WEST SUSSEX COUNTY COUNCIL
FLOOD RISK MANAGEMENT CONSULTATION

PLANNING REFERENCE: BN/44/18/DOC

LOCATION: Angels Nursery Yapton Road Barnham PO22 0AY

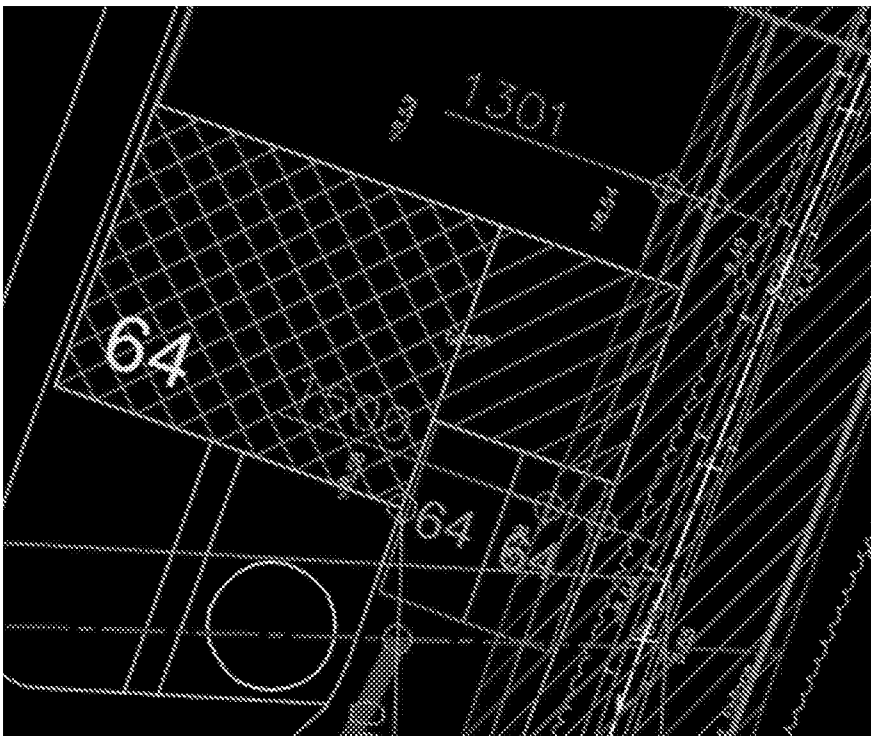
5. Nonetheless and without prejudice to 4 above there are 2 plots where some encroachment of structures occurs within the 3m zone and as requested I attach plans to illustrate that:

a) the extent of the encroachment is limited in both length and extent (see below) therefore access for such a modest depression could easily be achieved by machinery from around the building sides (in the unlikely event that such access was needed).

b) there is ample space for access in the vicinity of plot 95 from Murrells Field side which is protected Public Open Space

c) the “encroachment” on plot 64 is only for the length of a garage and there is no approved layout (yet) for the adjoining site.

The details of the footprint location in relation to a 3m easement are illustrated below.

1074mm encroachment to N side of Plot 95

750mm encroachment to S side of Plot 95

1301mm encroachment to N side of Plot 64
1500mm encroachment to S side of Plot 64

5. On this basis, the layout for the site requires amending to ensure that a 3m easement is maintained either side of the watercourse at the western boundary of the site. Specifically plot 95 needs to be reconfigured to avoid encroaching on this easement.

The WSCC policy regarding easement for maintenance plant is needed to allow effective maintenance and minimise future flood risk. This includes minimising the risk of residents dumping material into watercourses where boundary fences are immediately adjacent to a watercourse, a common problem where garden fences are juxtaposed with watercourses.
